**CITY OF AVON LAKE
PLANNING COMMISSION
150 Avon Belden Road
Avon Lake, Ohio 44012
(440) 930-4110**

**AGENDA
Tuesday, April 1, 2025
7:00 PM
City Council Chambers**

Case No. CPC-25-2, Pulte Homes of Ohio LLC, Zoning Map Amendment for the property located at the southeast corner of Walker Road and Avon Belden Road (SR 83), changing from Single-Family Residence (R-1A) and General Commerce (B-2) to Multi-Family Residence (R-3). Applicable Code Sections: 1214.02: Code Text and Map Amendments apply.

Reference: Concept Plan/Rezoning
Harbor Crest Townhouse Development

**HARBOR CREST
CONCEPT PLAN**
FOR
PULTE HOMES

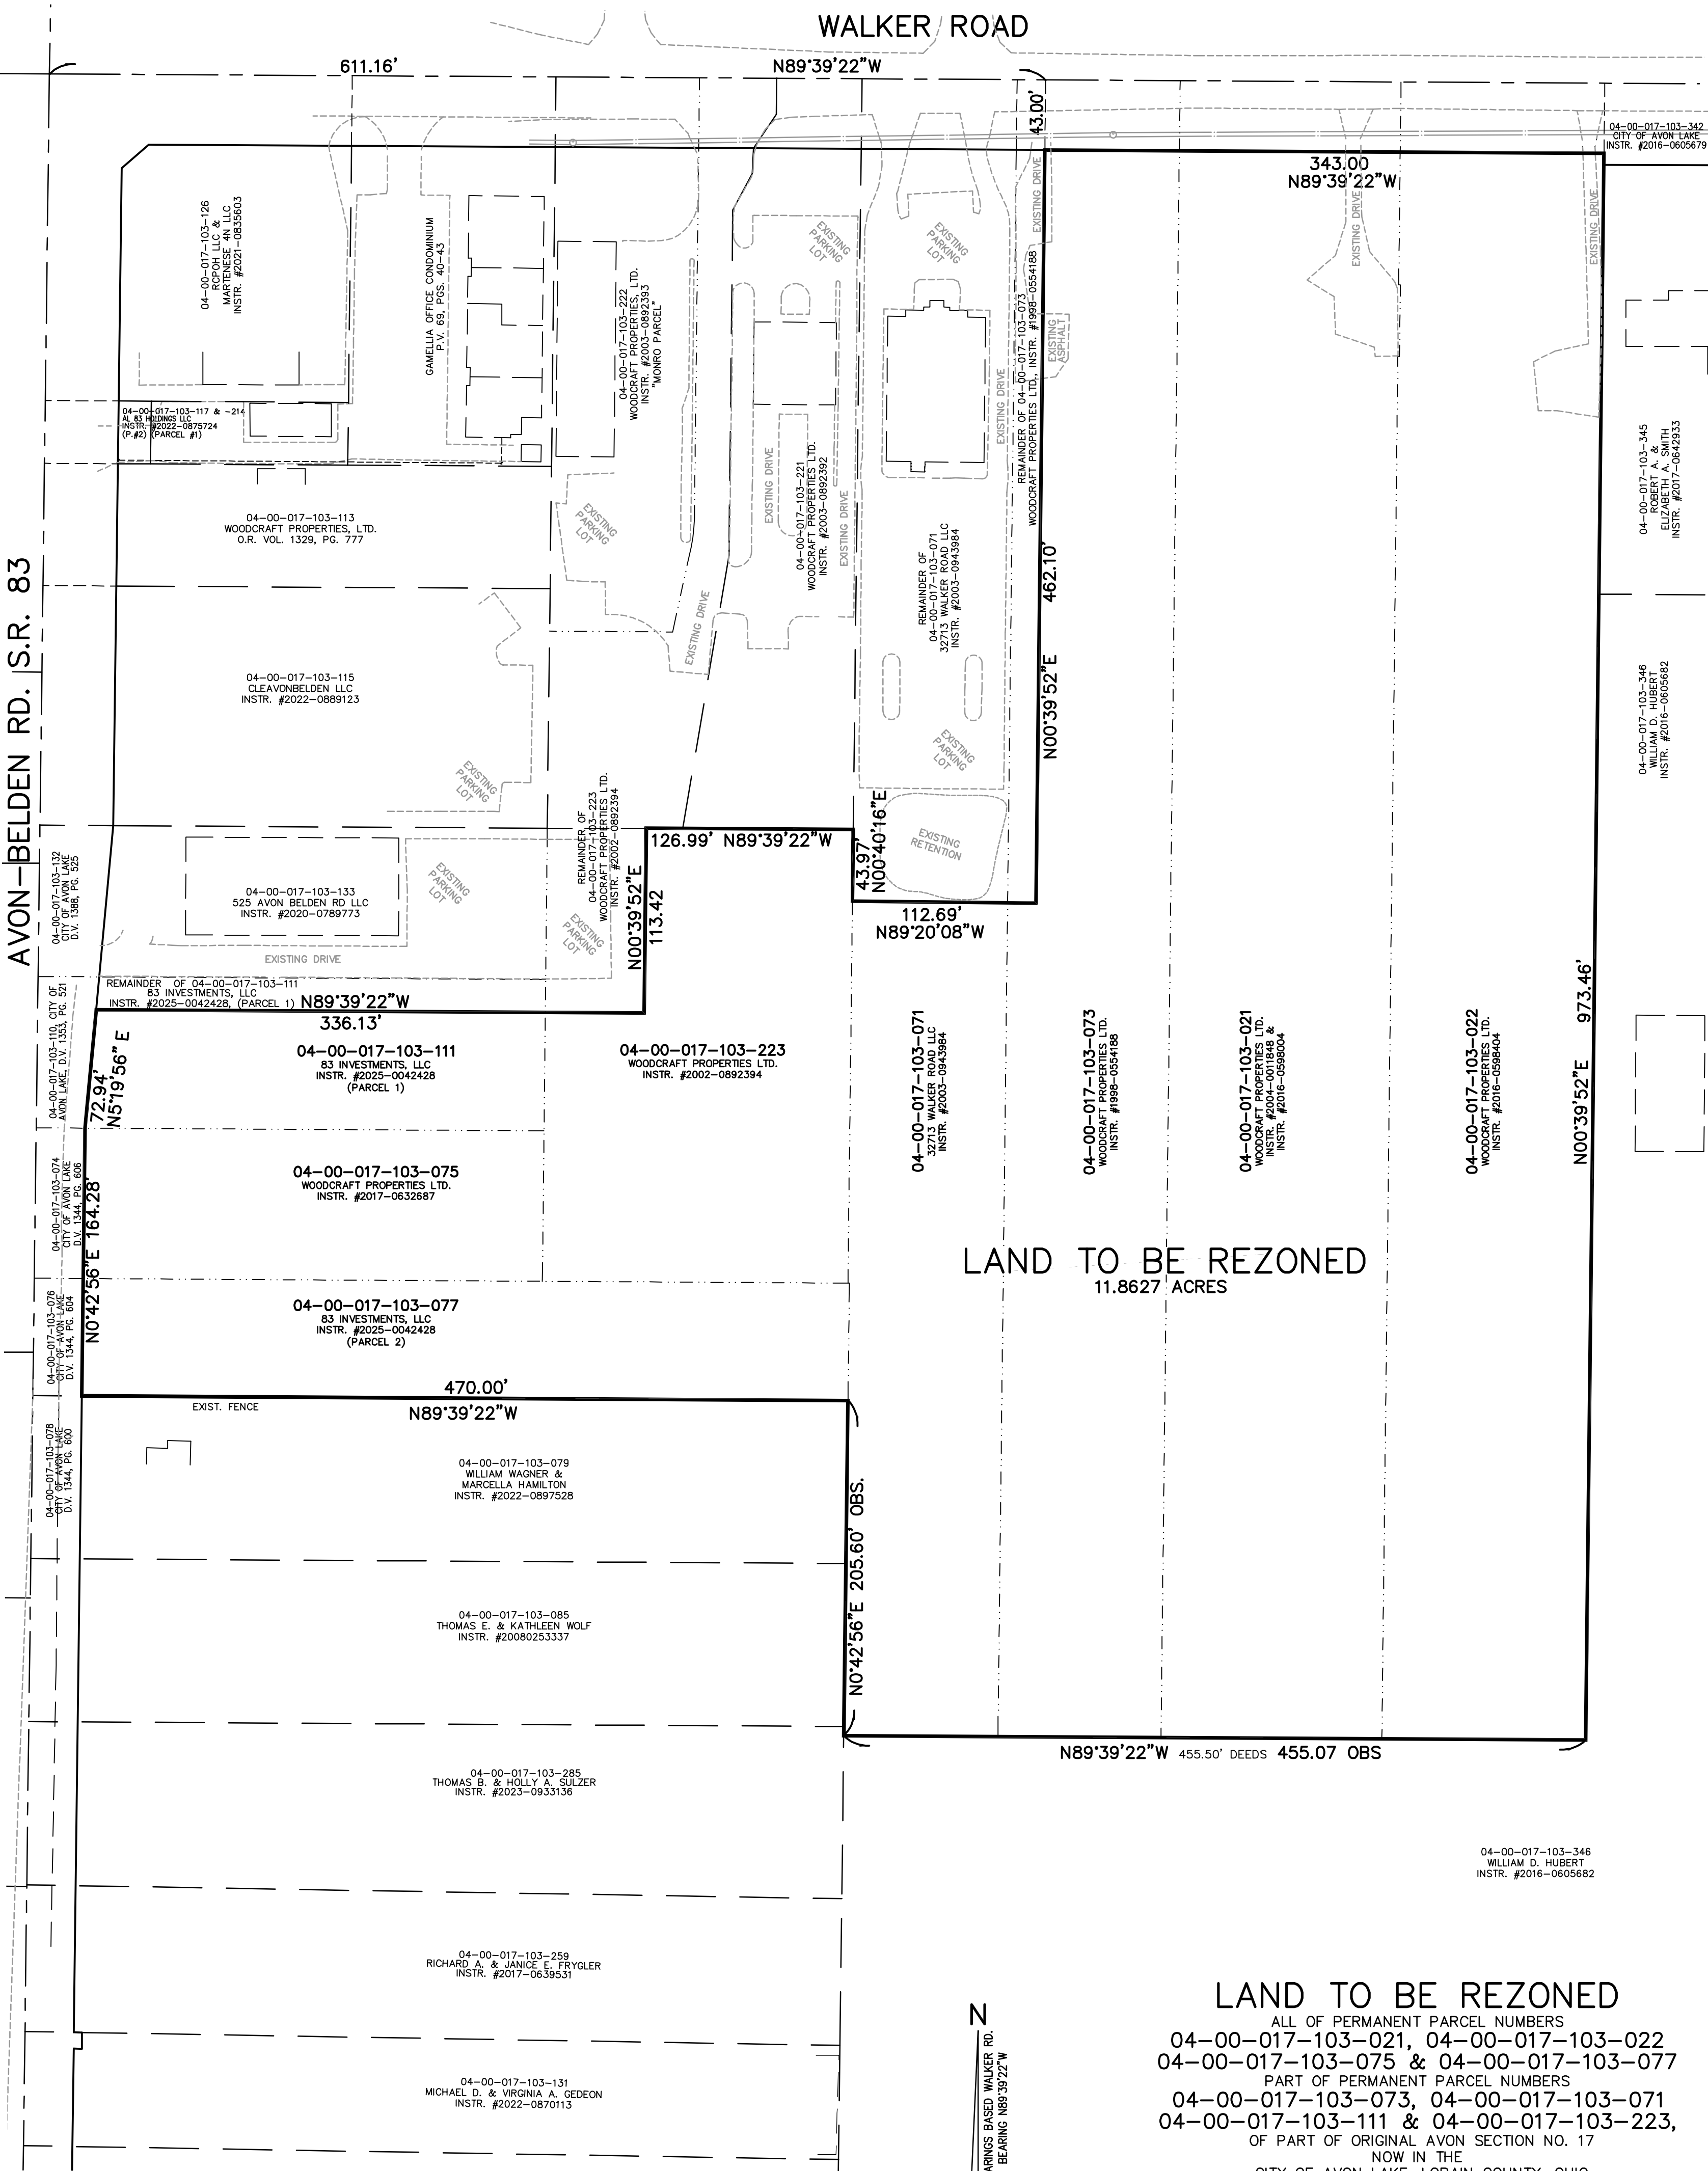
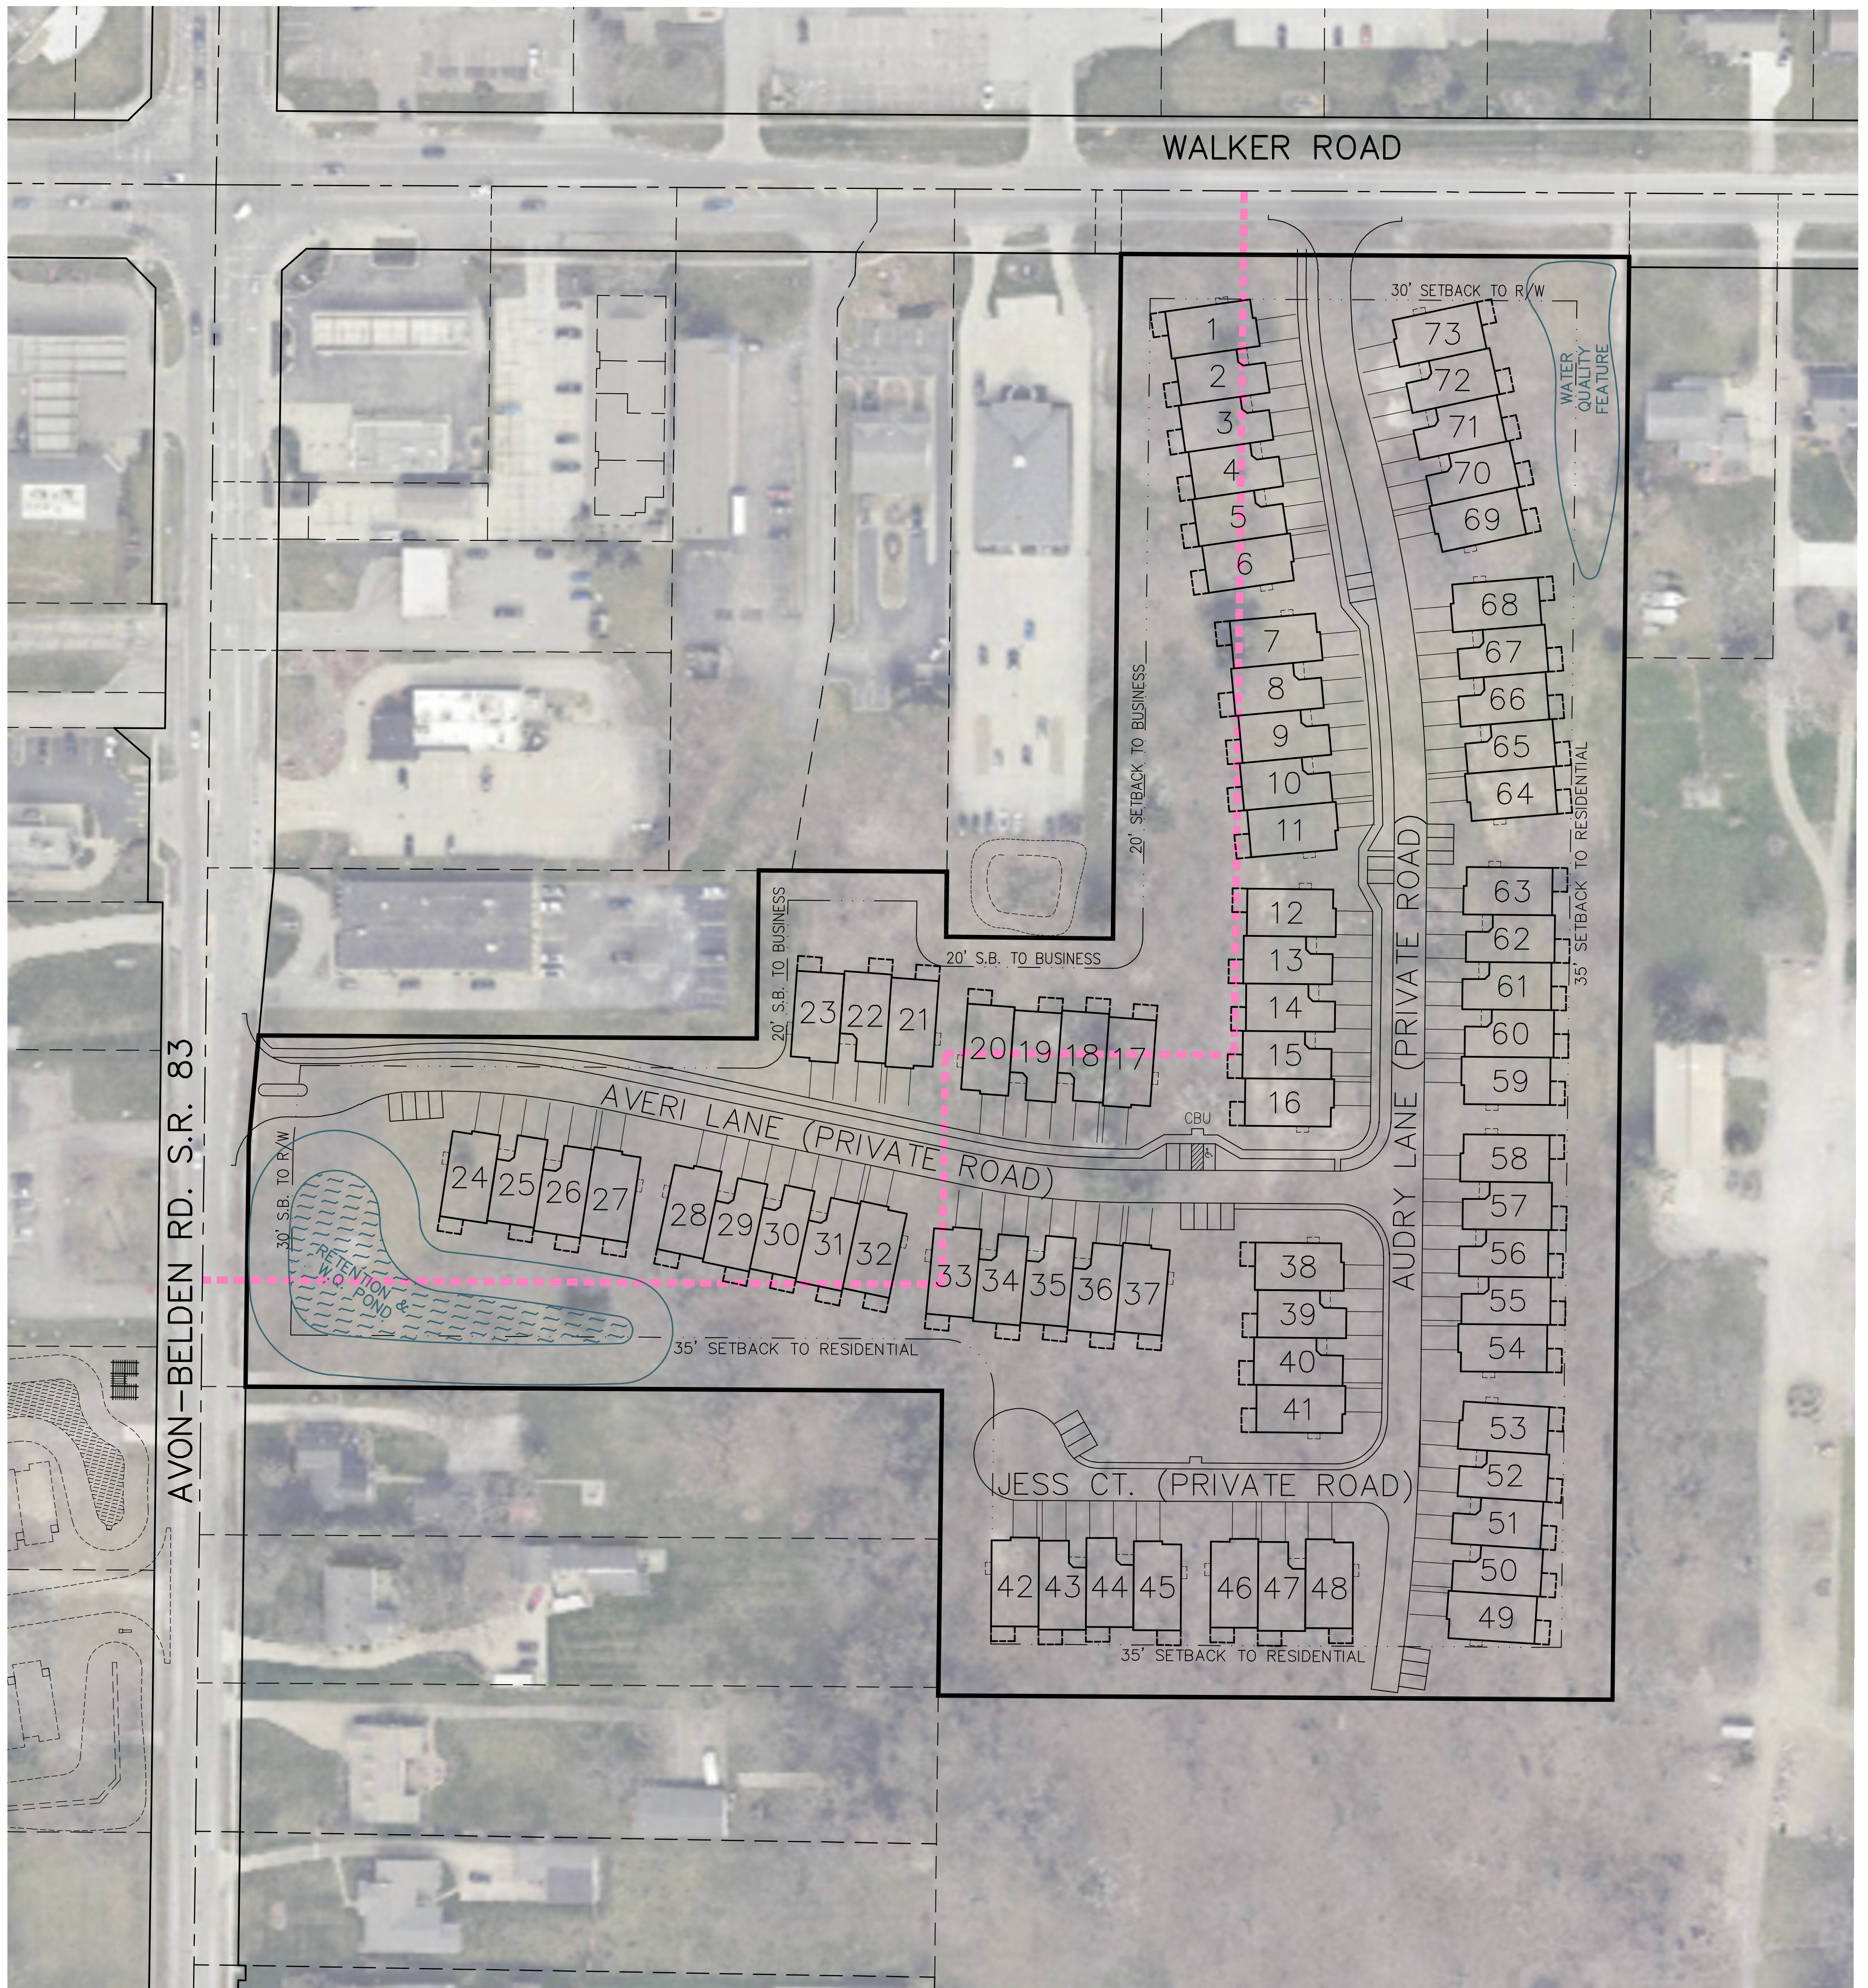
- a. With the proposed rezoning, buffering will be needed. As shown on the conceptual plan, the applicable setbacks have been depicted and adhere to the current requirements of the Planning & Zoning Code. Specific types of buffering (fence, landscaping, etc.) will be required but are not needed for this rezoning review and will be reviewed at the time of plan approval and improvement plans.

- b. As depicted on the conceptual plan, the CBU is shown off the street, with designated parking spaces. This helps to prevent vehicles from obstructing the roadway and is appreciated.

- c. As mentioned in DRC in Early February, by the Fire Chief, turnarounds (most likely a "T" for a 3-point turn) should be added at the end of the roads at unit 43 and unit 53. This not only helps emergency vehicles exit efficiently but also daily vehicles such as delivery trucks, amazon, UPS, etc. Prevents them from turning around on driveways.

- f. Streets are listed as private in the table but should also be labeled on the plan itself.
 - g. Sidewalks should be added on both sides of the street to improve the walkability and connectivity of the neighborhood to the surrounding streets, etc. Comp plan alludes to connectivity and walkability.

The concept plan has been revised in response to comments that were received to date in the following manner:

- 1) The project limits were revised to eliminate a small, isolated area of land that was unsuitable for development and would have been difficult to access for any recreational uses.

- b. Moving the divided entry so the landscaped island will be provided along Avon Belden Rd instead of Walker Rd.
- 4) The Southeast portion of the project was realigned to provide:
